Product Change Notification

Change Notification #: 119468-00

Change Title: Select Intel® Killer Wi-Fi 6E AX1675 PCI Card
Intel® Killer Wi-Fi 6E AX1675 w (Gig+), 1216,
Intel® Wi-Fi 6E AX210 (Gig+), 1216,
PCN 119468-00, Label, Transport Media
Packaging Logos, Label, and Desiccant Bag Update

Date of Publication: March 02, 2023

Label, Transport Media

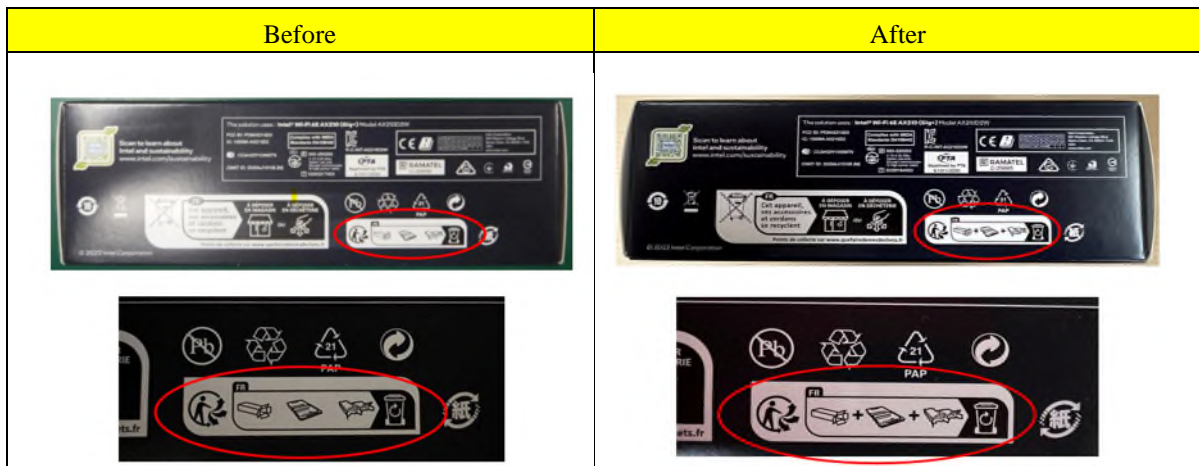
The Intel® Wi-Fi 6E AX210 and the Intel® Killer™ Wi-Fi 6E AX1675 1216 SKUs listed in the products affected table below will undergo the following changes.

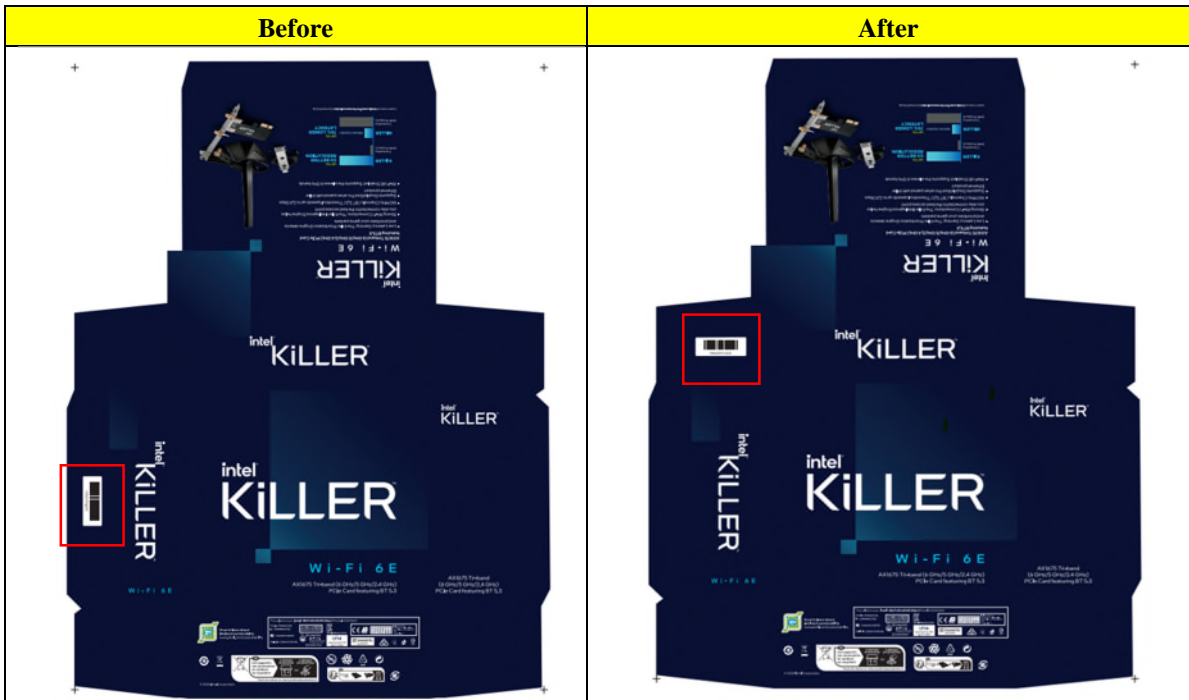
- 1) Increase the quantity of desiccant bag from 1 to 2 pieces (Not applicable to AX210.D2WG.NVXC).
- 2) Update Japan regulatory ID with Wi-Fi 6E certification on Disti box label (Not applicable to AX210.D2WG.NVXC).
- 3) Add the plus signs in the French Triman logo which is located on the product packaging of AX210.D2WG.NVXC.

4) Relocate the Intel Part Number barcode on the product packaging of AX210.D2WG.NVXC.
